ADDENDUM NO. 1

LIBERTY AND WESTCHESTER INTERMEDIATE SCHOOLS - ATHLETIC SITE PROJECTS Chesterton, IN 46304

ADDENDUM ONE

Addendum One (AD.01) to the drawings and specifications prepared by Gibraltar Design for **Liberty and Westchester Intermediate Schools Athletic Site Projects** for Duneland School Corporation, Chesterton, Indiana.

WIS P-004

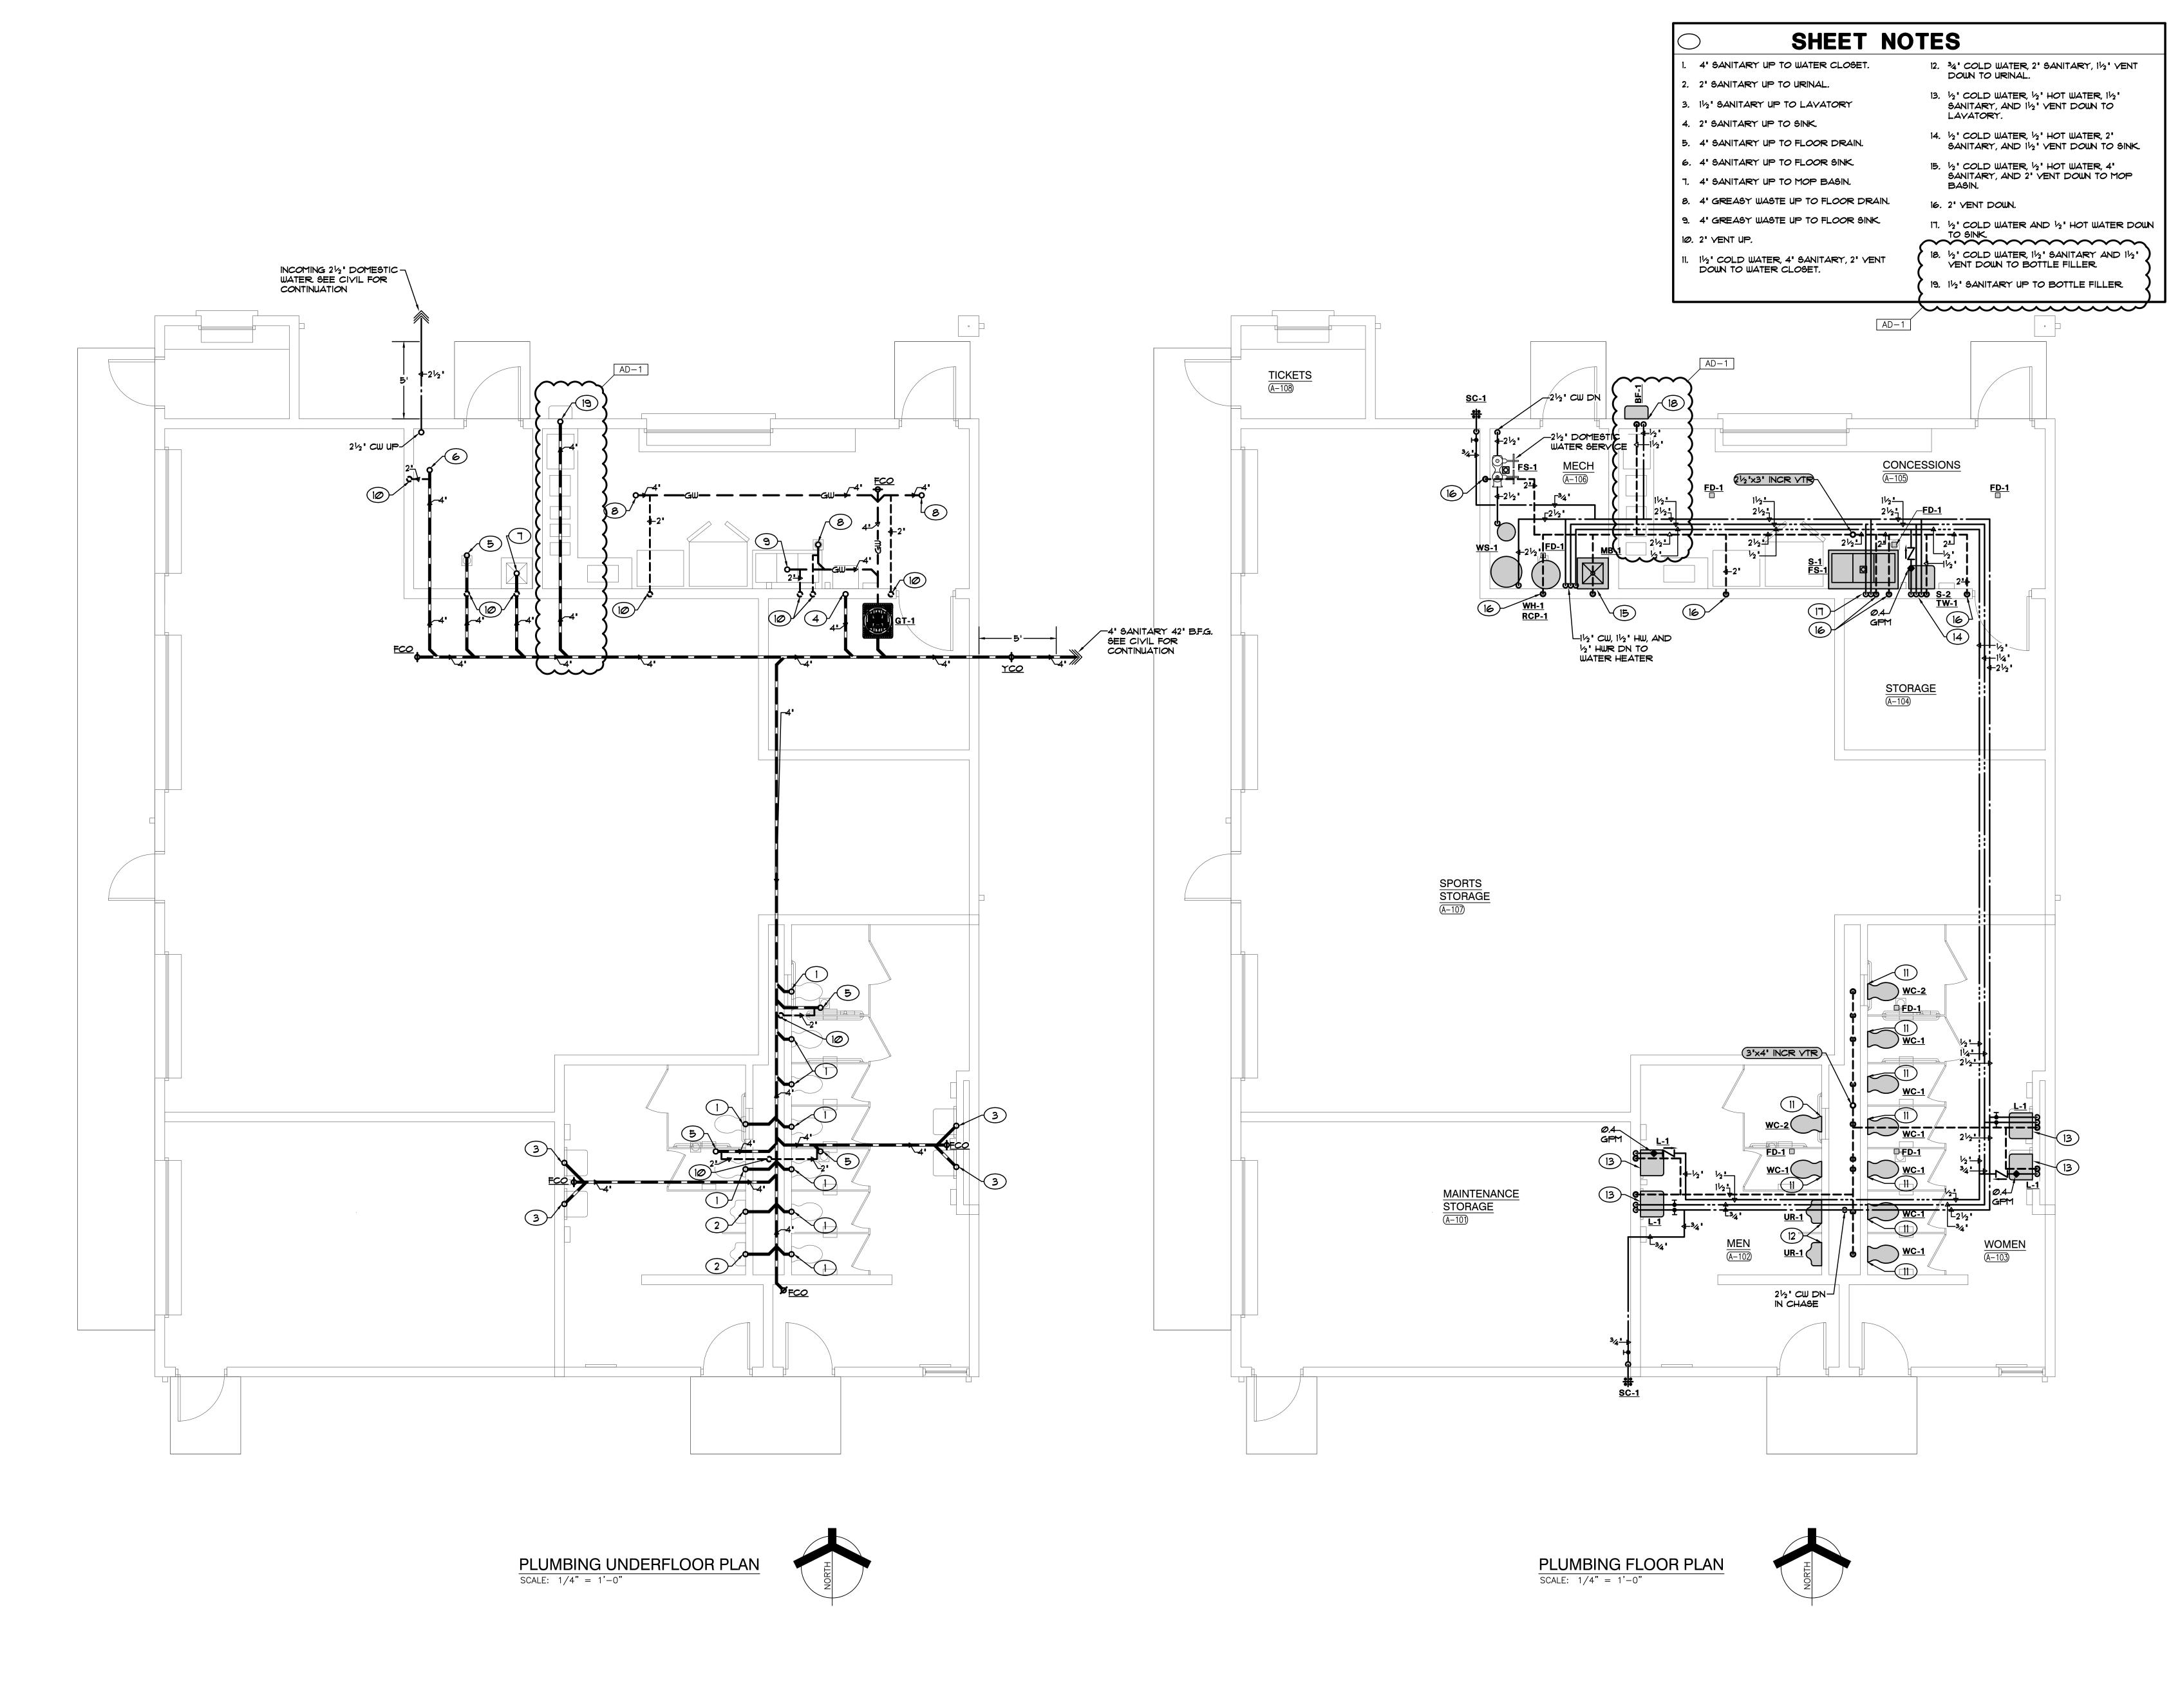
8. Sheets P-002 and P-004

A. Refer to two (2) revised full-size drawings, included in this Addendum, for revised Plumbing Riser Diagram.

© GIBRALTAR DESIGN SHEET P-101

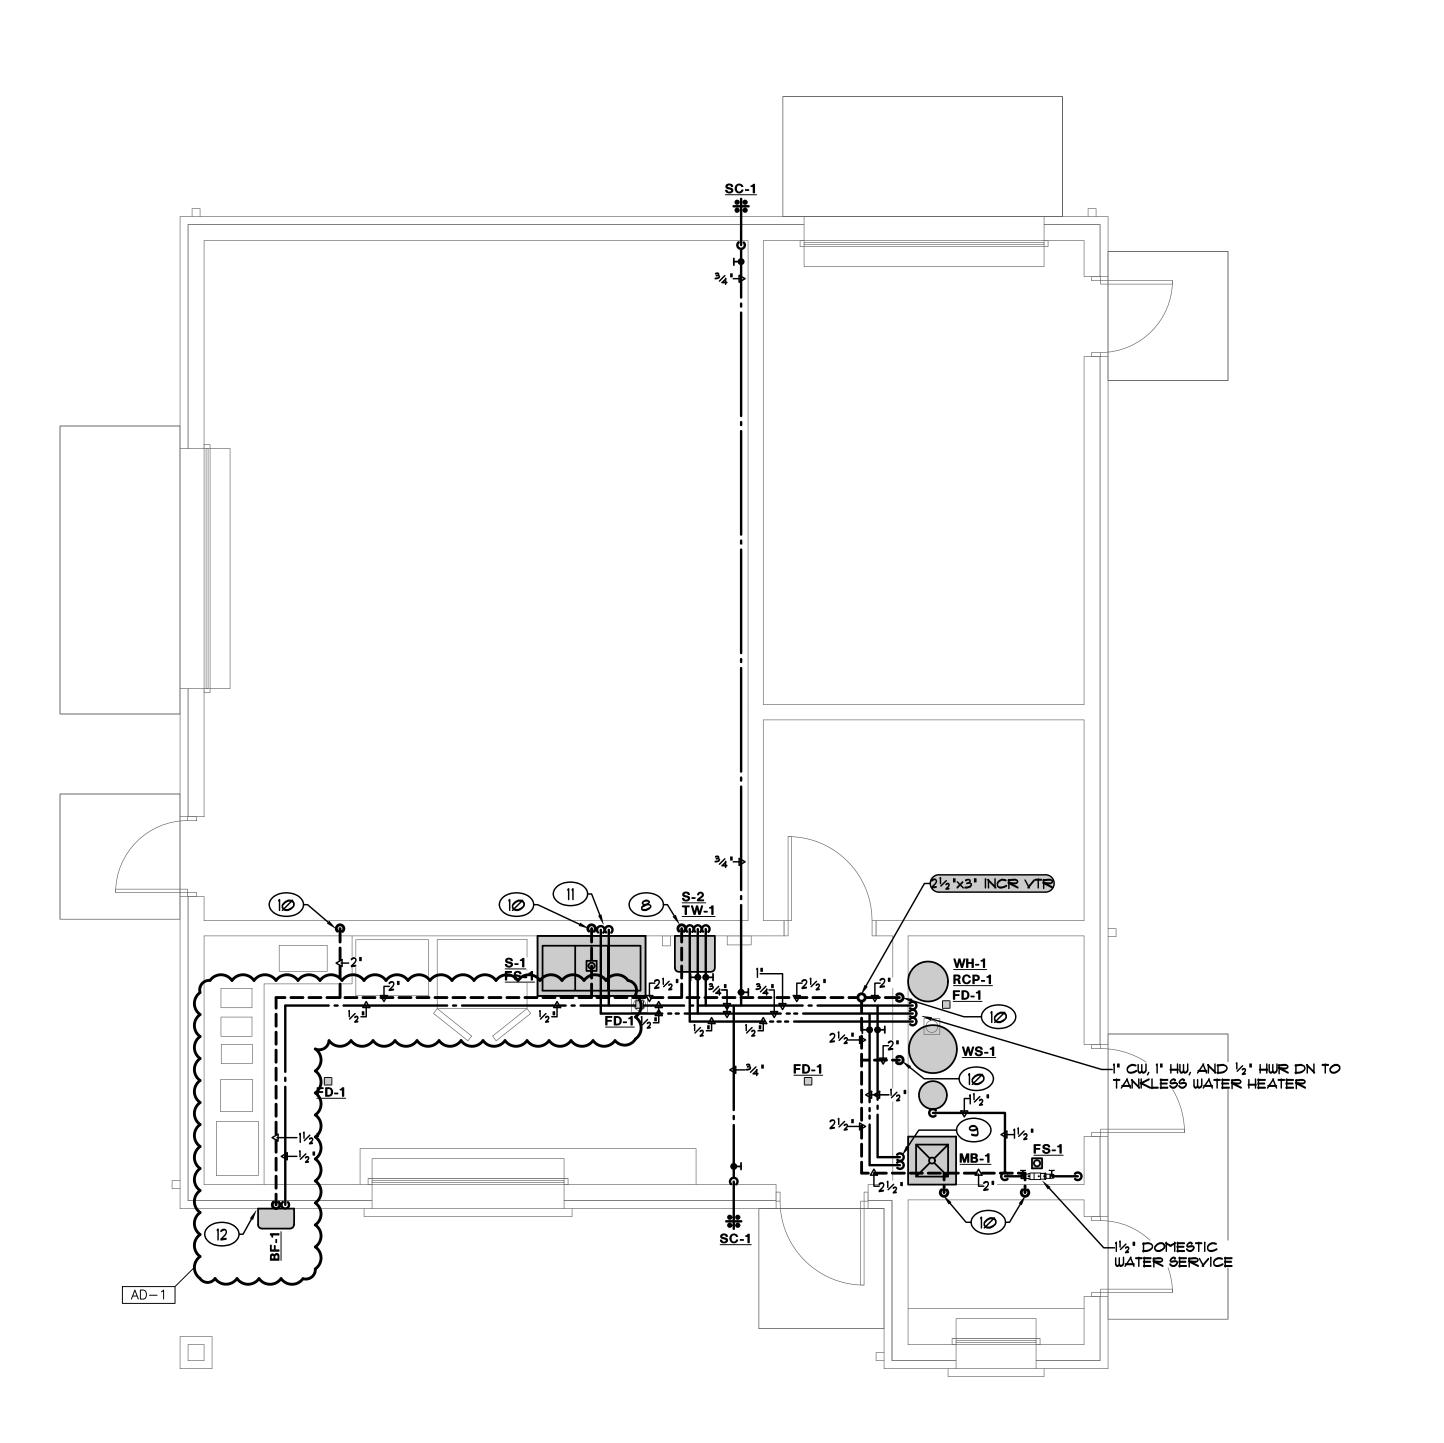
9. Sheets P-101 and P-102

A. Refer to two (2) revised full-size drawings, included in this Addendum for added bottle filler and associated piping.

- 1. 2" SANITARY UP TO SINK.
- 2. 4" SANITARY UP TO FLOOR DRAIN.
- 3. 4" SANITARY UP TO FLOOR SINK
- 4. 4' SANITARY UP TO MOP BASIN.
- 5. 4" GREASY WASTE UP TO FLOOR DRAIN.
- 6. 4" GREASY WASTE UP TO FLOOR SINK.
- 7. 2" YENT UP.
- 8. ½" COLD WATER, ½" HOT WATER, 2" SANITARY, AND 1½" VENT DOWN TO SINK.
 9. ½" COLD WATER, ½" HOT WATER, 4" SANITARY, AND 2" VENT DOWN TO MOP BASIN.
- 10. 2" VENT DOWN.
- 11. 1/2" COLD WATER AND 1/2" HOT WATER DOWN TO SINK.
- 12. 1/2" COLD WATER, 11/2" SANITARY AND 11/2" VENT DOWN TO BOTTLE FILLER.
- 13. 11/2" SANITARY UP TO BOTTLE FILLER.
